September 23, 2024
HSC419A, 421, 421A ANT LAB RENO
UTM PROJECT NO. P300-23-095
To: All Bidders

ARCHITECTURAL ADDENDUM A-1

1 DEMOLITION PLAN
A1.0 SCALE 1:75

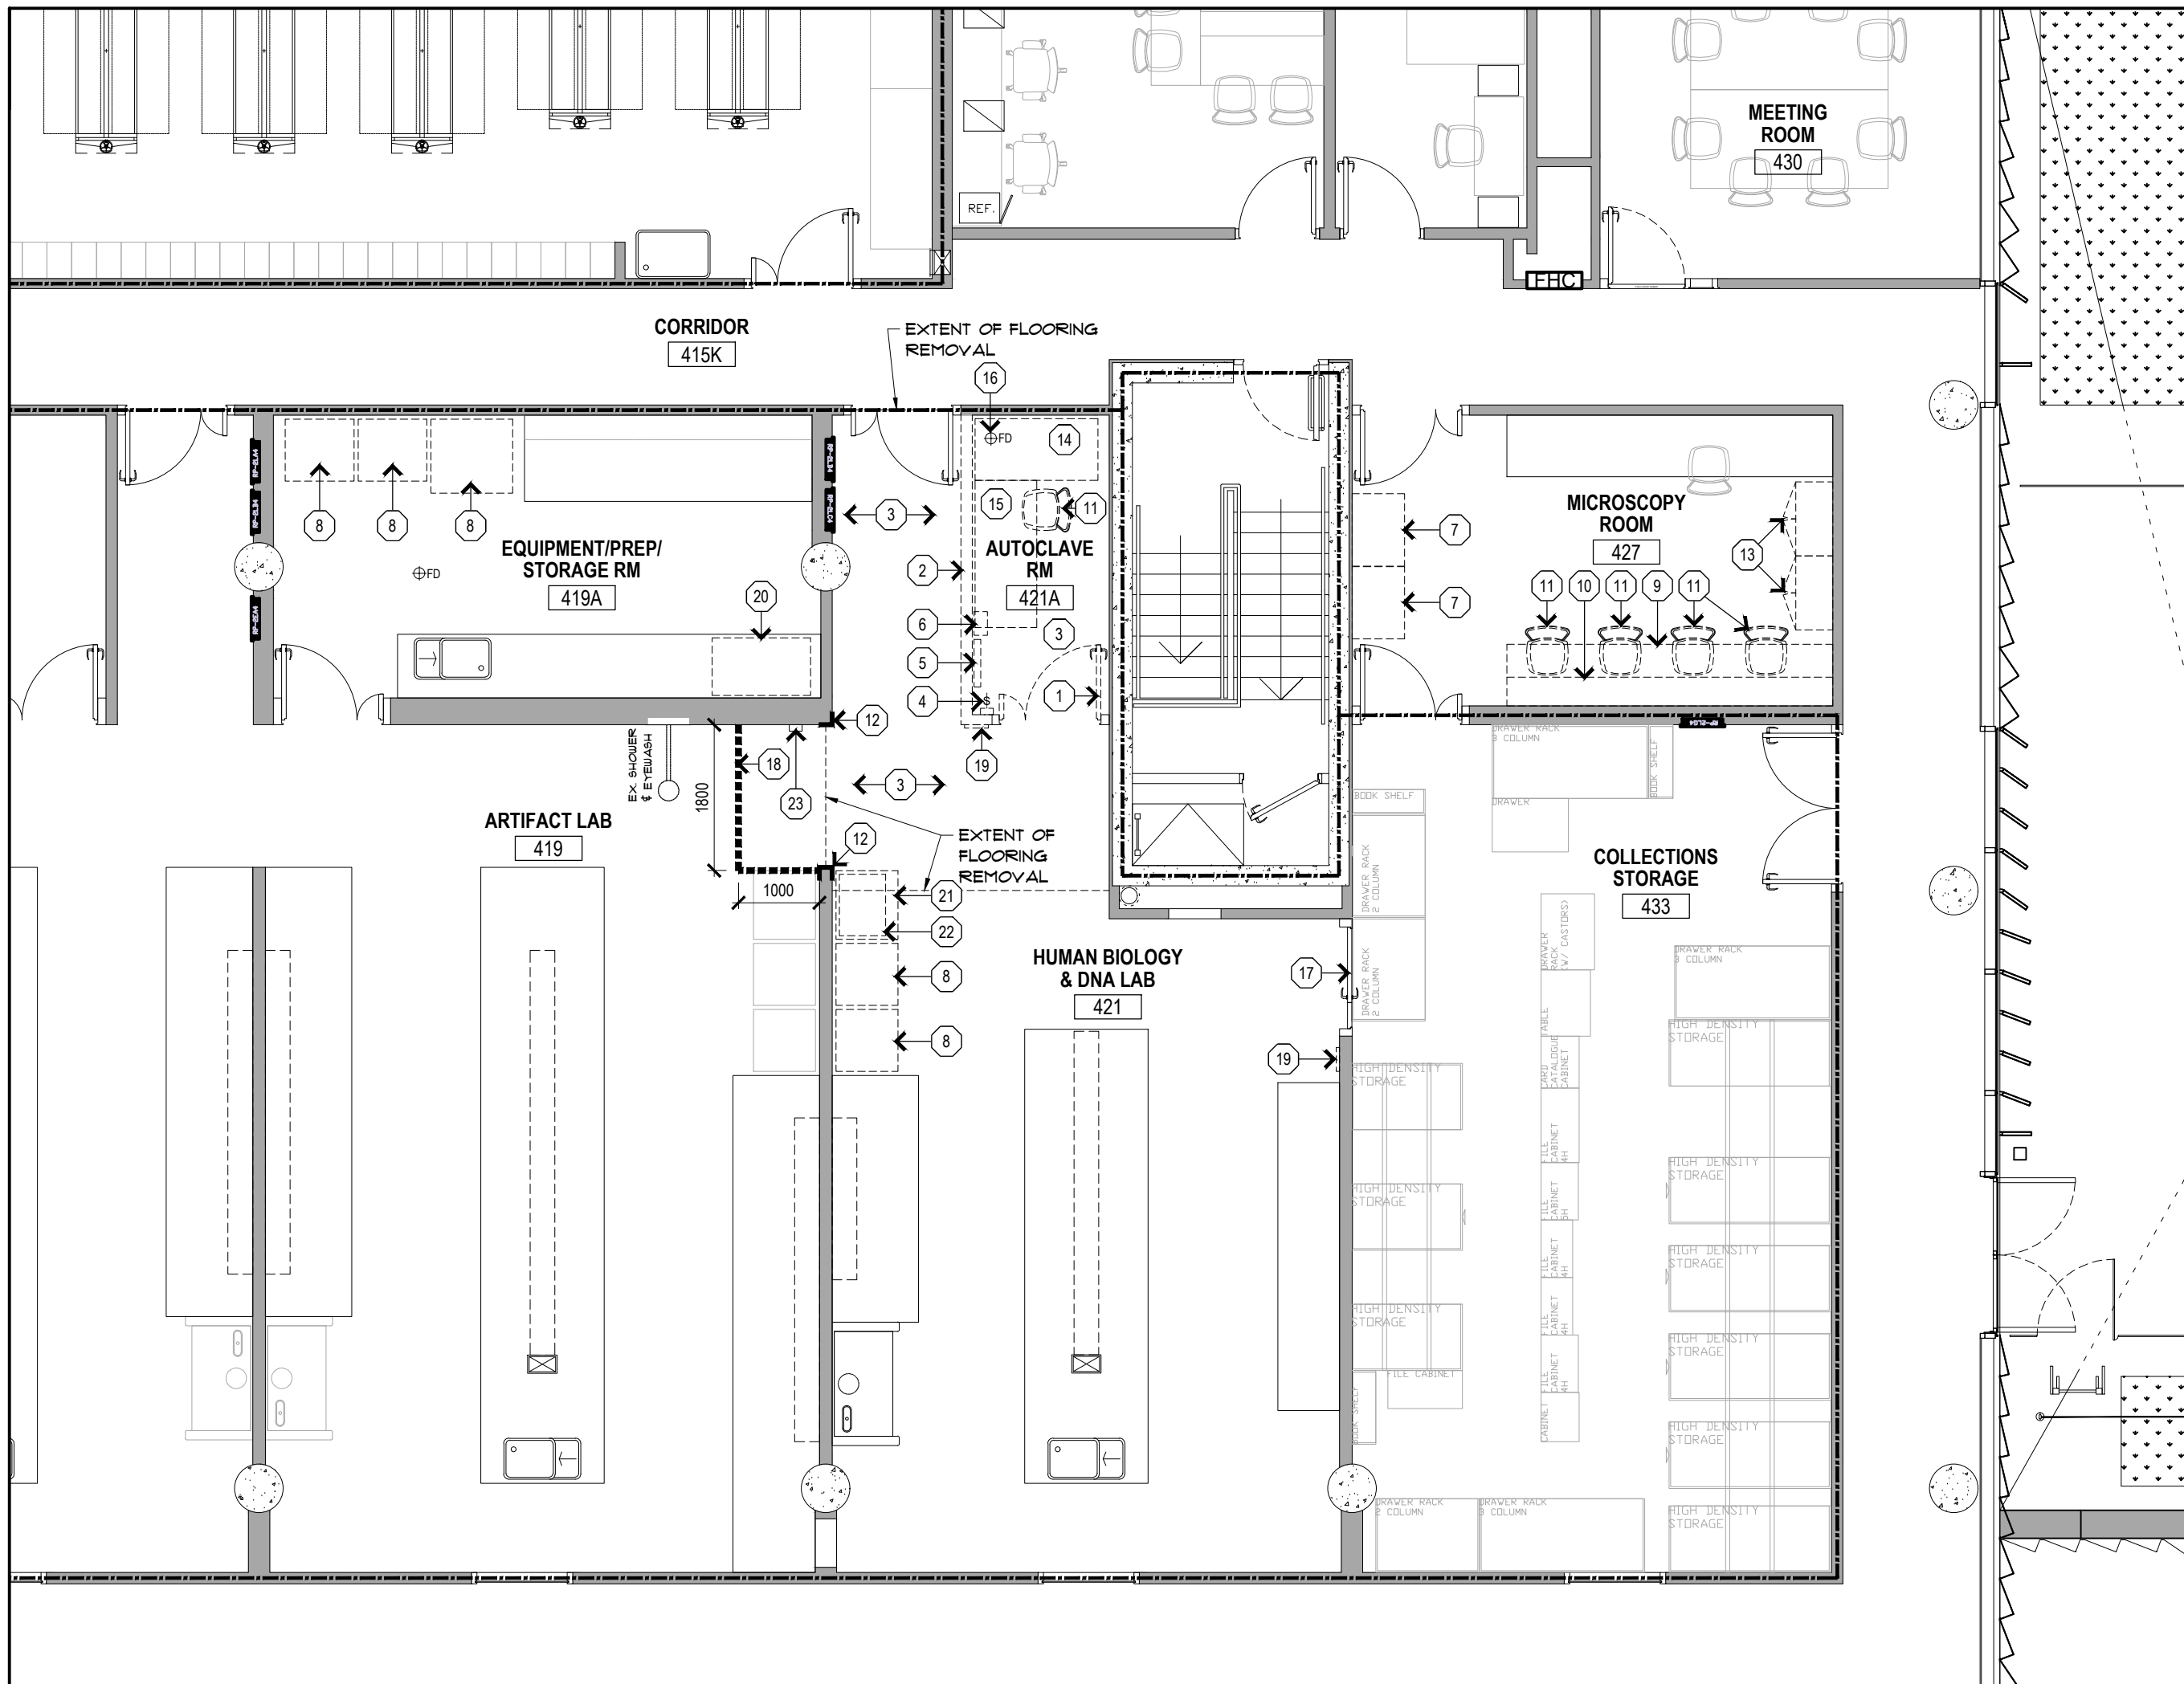
1. **Architectural Drawing A1.0 Demolition Plans (Re-issued)**
 - a. Revise Drawing Note - Demolition Plan, #19 as indicated.
2. **Architectural Drawing A2.0 Proposed Plans, Schedules (Re-issued)**
 - a. Revise Drawing Note – Proposed Plan, #21 as indicated.

- 18 DUST-TIGHT TEMPORARY CONSTRUCTION HOARDING. PROTECT ADJACENT FINISHES. REFER TO SPECIFICATIONS.
- 19 CAREFULLY REMOVE SIGNAGE. RETURN RM SIGN '433' TO OWNER. STORE RM SIGN '421A' FOR REUSE.
